UNITED STATES PATENT AND TRADEMARK OFFICE

APPLICATION NO.	FILING DATE	FIRST NAMED INVENTOR	ATTORNEY DOCKET NO.	CONFIRMATION NO.
10/814,794	04/01/2004	Yo Hyun Song	1594.1429	4959

Office Action Summary	Application No.	Applicant(s)	
	10/814,794	SONG ET AL.	
	Examiner	Art Unit	
	Philip Gabler	3637

DETAILED ACTION

McCollom '839 Figures 1-3

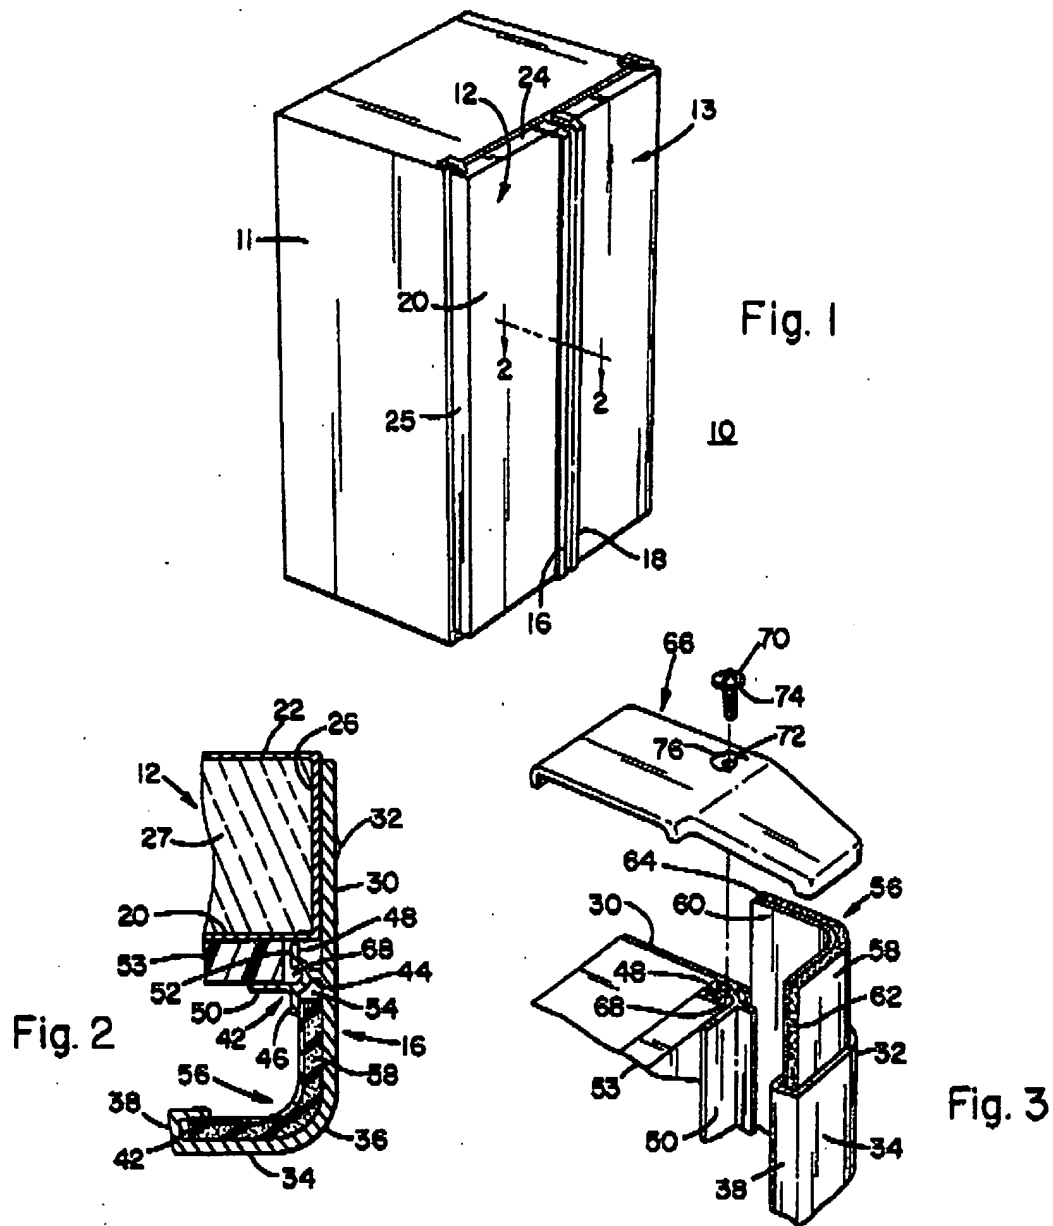
8. Claim 1 is rejected under 35 U.S.C. 102(b) as being anticipated by McCollom (US Patent Number 5412839). McCollom (Figures 1-3) discloses a refrigerator (10) comprising: doors (12, 13) for opening or closing storage chambers (in 11, see column 1 lines 59-62); door handles (16,18) respectively provided at the doors; buffer members (56) of an elastic material respectively provided for the door handles and capable of making good tactile sensations when gripping the door handles; and deviating prevention members (66) capable of preventing the buffer members from being deviated from the door handles.

Exhibit 1: Roberts et al. ‘349 Figures 1, 2, and 5

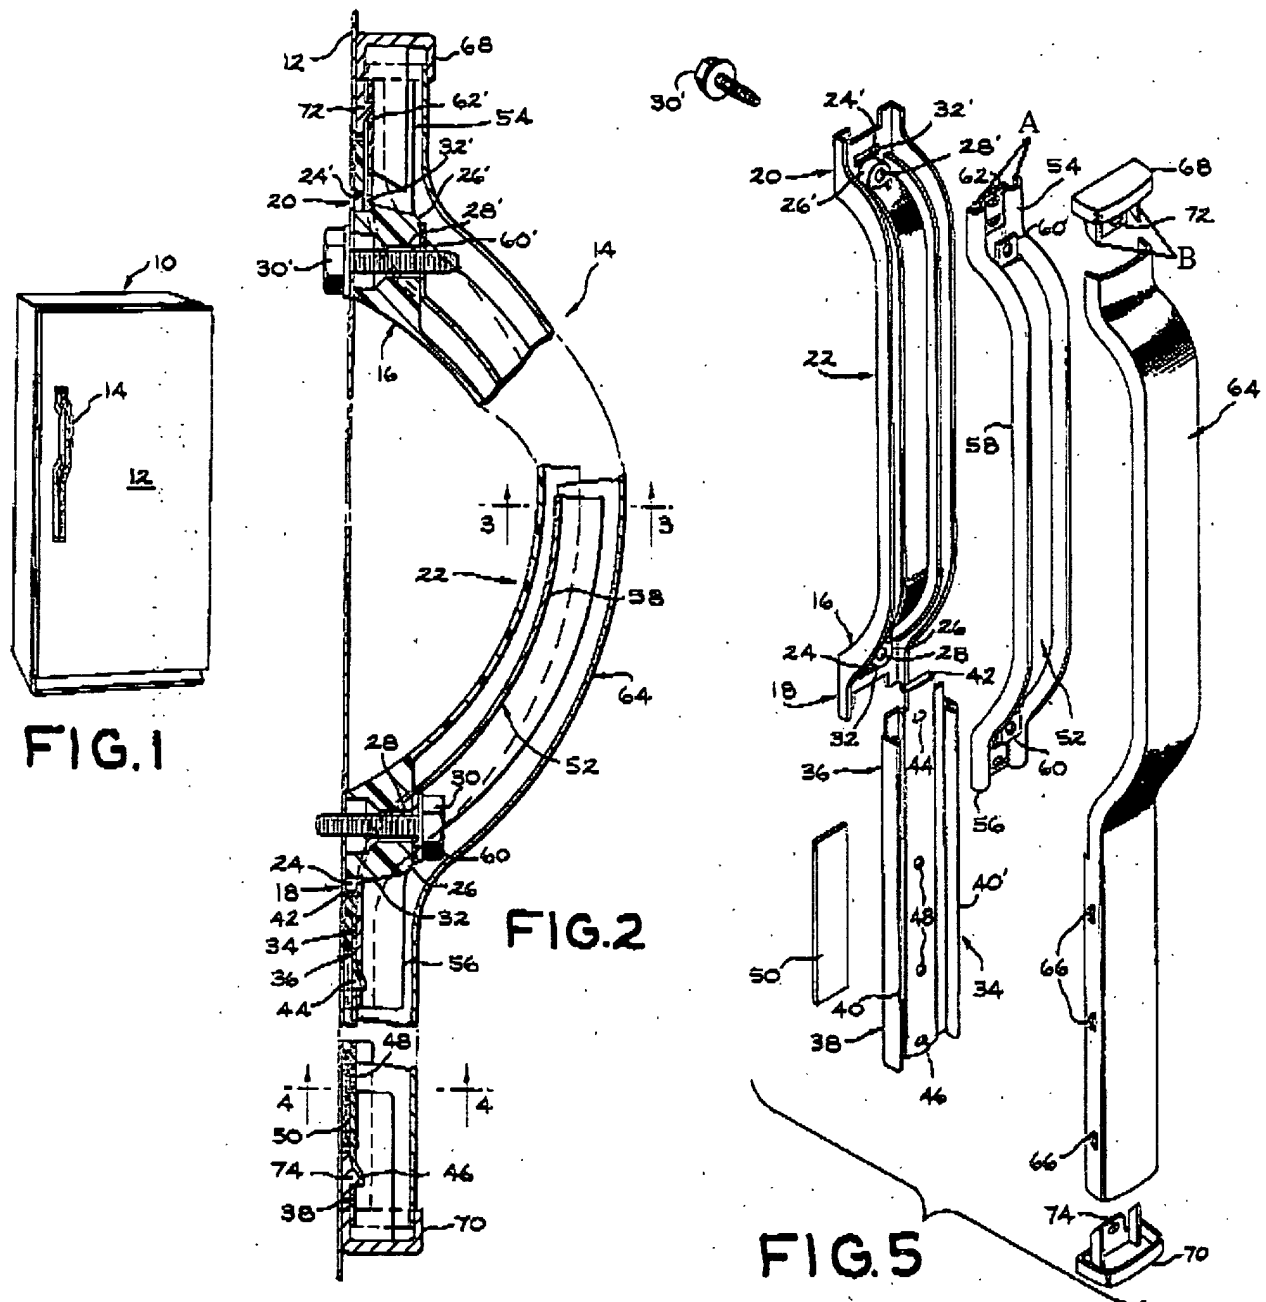
10. Claims 2, 3, 5, and 6, as best understood, are rejected under 35 U.S.C. 103(a) as being unpatentable over McCollom in view of Roberts et al. (US Patent Number 3995349). McCollom discloses a refrigerator as recited in claim 1 including handles comprising: a fixing portion (30) fixed to a free end of the door; a front extension (portion of handle between 30 and 36), which extends in a front direction of the door from the fixing portion; a side extension (34, 36), which is bent to extend from an end of the front extension toward a center of rotation of the door; and an insertion groove (42) formed at an inner surface of the side extension for inserting the buffer member. McCollom does not disclose a deviating prevention member located in the insertion groove. Roberts (Figures 1, 2, and 5) discloses a refrigerator (10) with a handle (14) including a deviating prevention member (68) fitting in insertion grooves (viewed in Exhibit 1 as the grooves A of element 52 that receive portions B of 68). Accordingly, it would have been obvious to one of ordinary skill in the art at the time the invention was made to modify McCollom's handle to include a deviating prevention member fitting in an insertion groove as taught by Roberts because this arrangement would better secure the buffer member.

12. Regarding claims 5 and 6, McCollom, when modified by Roberts as described above, discloses a refrigerator as recited in claim 3 but does not disclose a fixing protrusion and an elastic deformation portion. Roberts however, further discloses the deviating prevention member is provided with a fixing protrusion (72) for fixing the deviating prevention member in an insertion groove, and a mating member is formed with a fixing groove (62) for the fixing protrusion to be inserted into; and the deviating prevention member is slidably supported, at opposite sides thereof, in the insertion groove (elements B supported in A), and provided at a center thereof, with an elastic deformation portion (portion surrounding 72), which can deform such that the fixing protrusion can be vertically varied. Accordingly, it would have been obvious to one of ordinary skill in the art at the time the invention was made to further modify McCollom's handle to include a fixing portion and an elastic deformation portion on the deviating prevention member as taught by Roberts because this would allow the deviating prevention member to be secured in the handle assembly.

DeVoe et al. '195 Figures 1 and 5

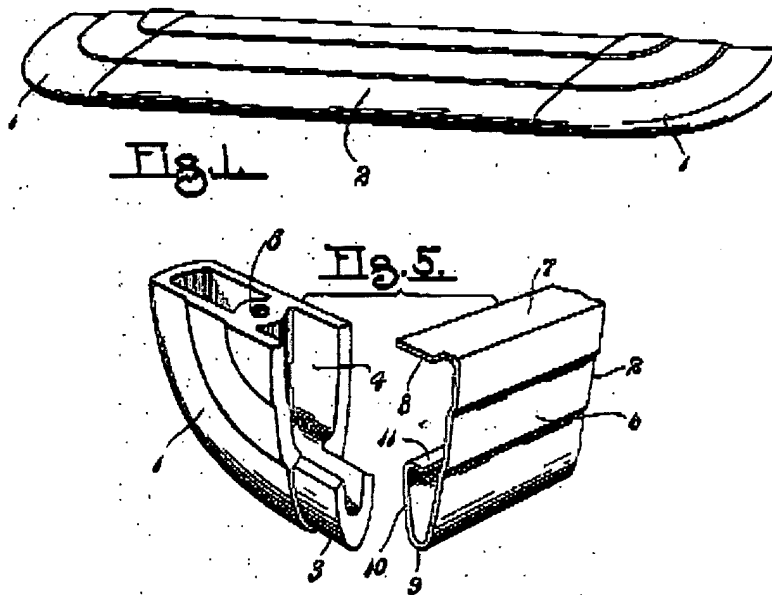
13. Claims 4 and 7, as best understood, are rejected under 35 U.S.C. 103(a) as being unpatentable over McCollom in view of Roberts and further in view of DeVoe et al. (US Patent Number 2151195). McCollom, when modified by Roberts as described above, discloses a refrigerator as recited in claims 3 and 6 but does not disclose a buffer member or deviating prevention member formed with an uneven portion. DeVoe (Figures 1 and 5) discloses an appliance handle with a gripping member (2) formed with an uneven surface and deviating prevention members (1) formed with the same uneven surface. Accordingly, it would have been obvious to one of ordinary skill in the art at the time the invention was made to modify McCollom's handle, previously modified by Roberts, to include uneven portions on the buffer and deviating prevention members as taught by DeVoe because this arrangement would provide a better grip on the handle for the user.
